FIGURE 2109.4.1
GRAPHICAL REPRESENTATION OF W_S AND W_T

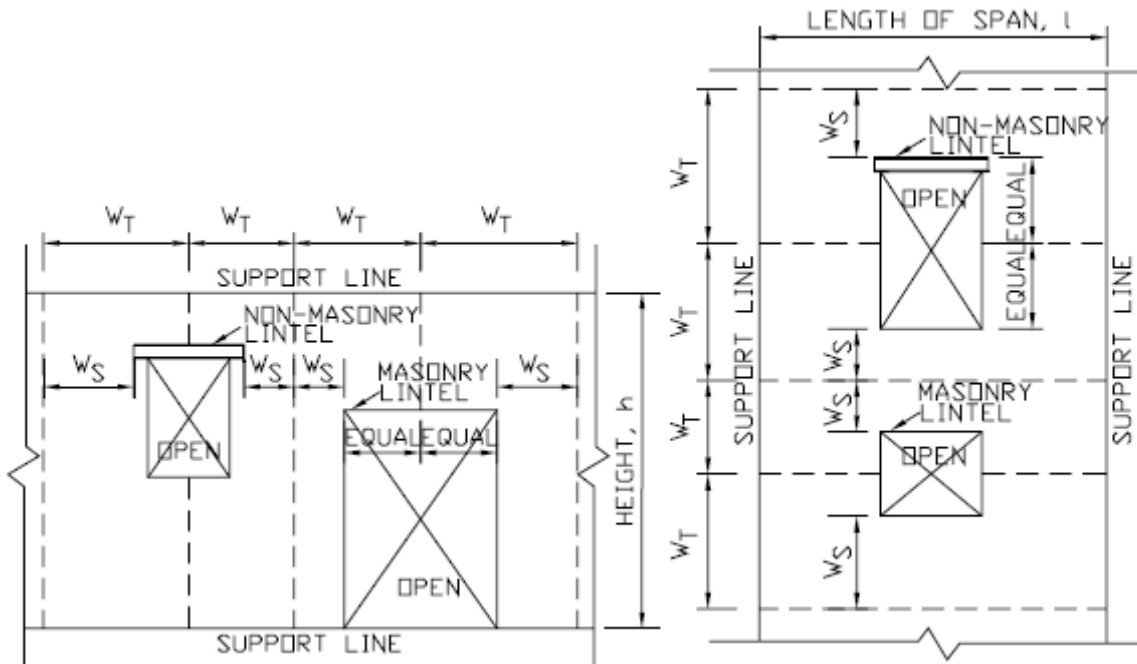
2109.4.1 Intervals Maximum l/t and h/t . Masonry walls without openings shall be laterally supported in either the horizontal or vertical direction such that l/t or h/t does at intervals not exceeding those the values given in Table 2109.4.1. Masonry walls with single or multiple openings shall be laterally supported in either the horizontal or vertical direction such that l/t or h/t does not exceed the values given in Table 2109.4.1 divided by $\sqrt{W_T/W_S}$.

W_S is the dimension of the structural wall strip measured perpendicular to the span of the wall strip and perpendicular to the thickness as shown in Figure 2109.4.1. W_S is measured from the edge of the opening. W_S shall be no less than $3t$ on each side of each opening. Therefore, at walls with multiple openings, jambs shall be no less than $6t$ between openings. For design purposes, the effective W_S shall not be assumed to be greater than $6t$. At non-masonry lintels, the edge of the opening shall be considered the edge of the non-masonry lintel. W_S shall occur uninterrupted over the full span of the wall.

W_T is the dimension, parallel to W_S , from the center of the opening to the opposite end of W_S as shown in Figure 2109.4.1. Where there are multiple openings perpendicular to W_S , W_T shall be measured from the center of a virtual opening that encompasses such openings. Masonry elements within the virtual opening must be designed in accordance with Section 2107 or 2108.

Fig. 1. Maximum Crack Width vs. Fiber Volume Fraction. PF5-8 and GF1 are different fiber types.

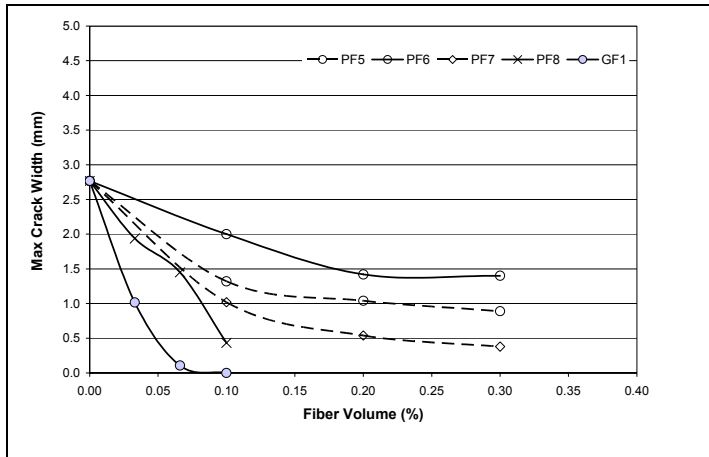
In Figures 1a and b some data related to five types of fibers are plotted. Notice that depending on the type of fiber, cracking in concrete can be completely eliminated. In Figure 2, some photographs showing crack control effectiveness of fibers are presented.

Figure 2. Control of Shrinkage Cracking with Fiber Reinforcement
 (Top: Plain; Middle: 0.1% Fiber; Bottom: 0.2% of Polymeric Fiber)

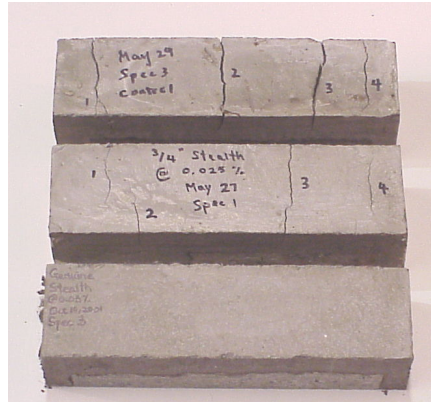
2. Fibers are highly effective in controlling shrinkage cracking in concrete. A comprehensive study recently carried out at the University of British Columbia (1,2,3,4) clearly demonstrated the effectiveness of fibers in controlling shrinkage cracking under harsh environmental conditions including low humidity and high temperatures.

Figure 3 (a). Full-Scale Load Test on Slab-on Grade and 3(b) Load-Displacement Curves.

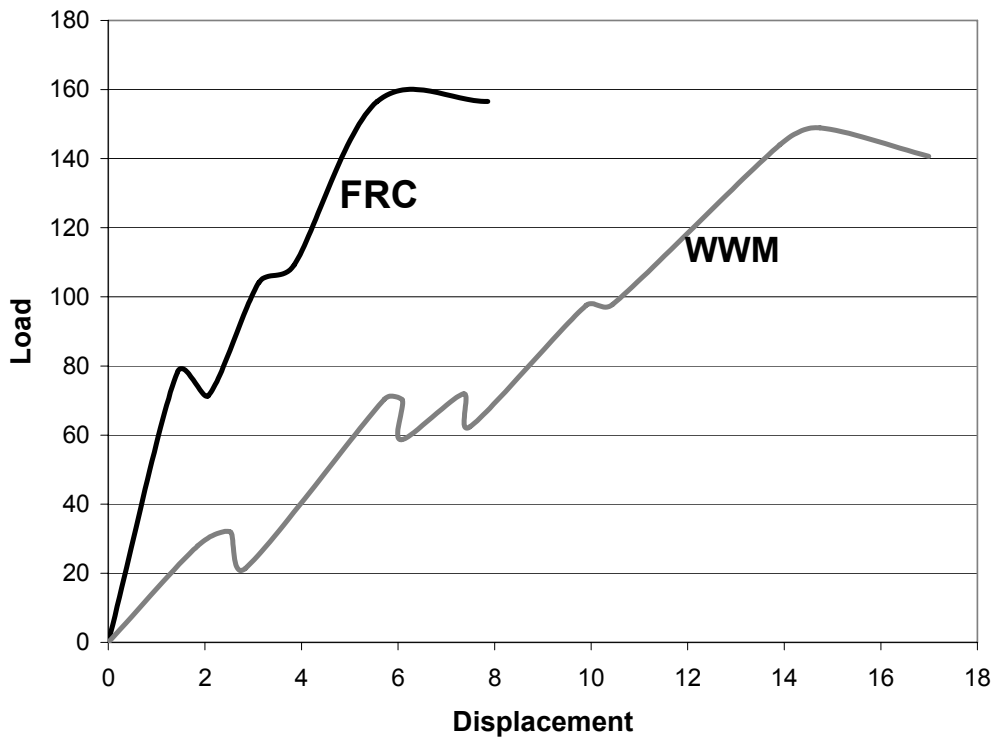
3. Even based on full-scale structural tests, the improved performance of slabs with fiber reinforcement over those with WWF can be seen. Some full-scale structural load responses are shown in Figure 3 (5). In these tests, 2.5 m x 2.5m x 0.1m slabs-on-grade were tested under a centrally applied load. One slab was reinforced with a welded wire mesh (WWM, or WWF) and the other with polymeric fiber at 3lb/yd³. Rubber pads were used to provide a sub-base with a uniform elastic reaction. Results indicated that the slab with fiber reinforcement supported a higher load at failure and also depicted a stiffer response.

Figure 4. (a) Influence of Fiber Reinforcement on Permeability of Unstressed Concrete and (b) Influence of Stress on Relative Permeability of Plain and Fiber Reinforced Concrete. Notice the impermeable nature of fiber reinforced concrete under both stressed and unstressed conditions

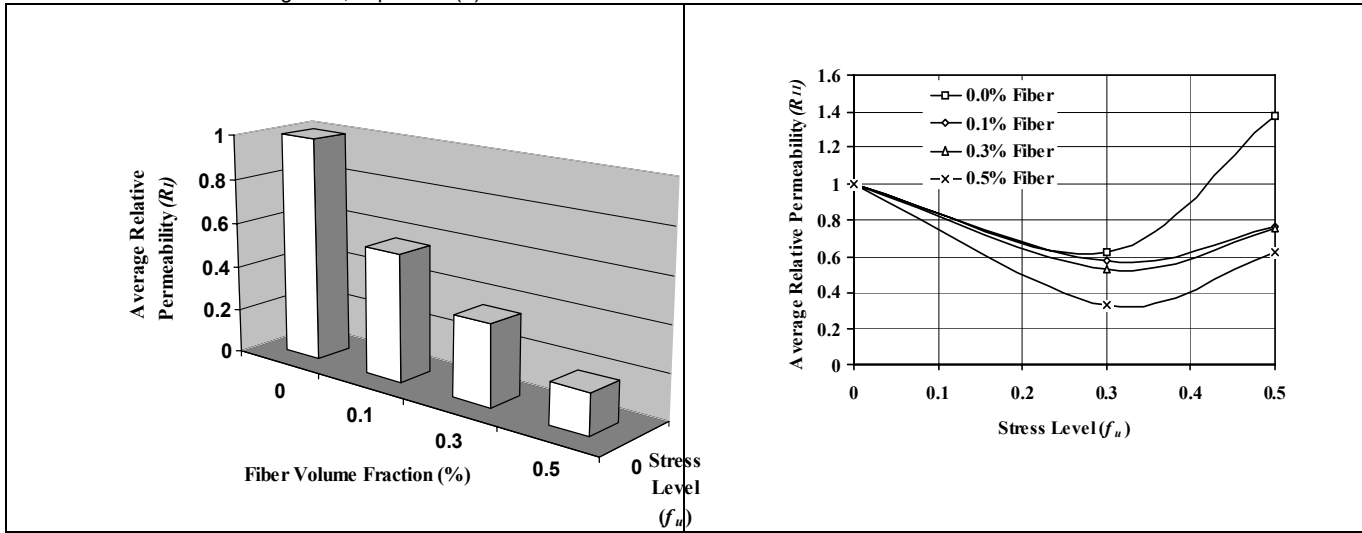
4. Finally, a few words on durability. The most important and pressing issue with decks reinforced with WWF today is the rampant corrosion of WWF that occurs due to ingress of chlorides. Corrosion of WWF in deck slabs has become a multi-billion dollar problem and one wonders why we continue to use this archaic type of reinforcement when superior alternatives (such as fiber reinforcement) are available. Fiber reinforcement is a far superior option in so far as durability is concerned as fiber reinforcement reduces concrete permeability under both unstressed and stressed conditions (Figure 4, Ref. 6) and even reduces the corrosion rates of reinforcing steel, in present (7).
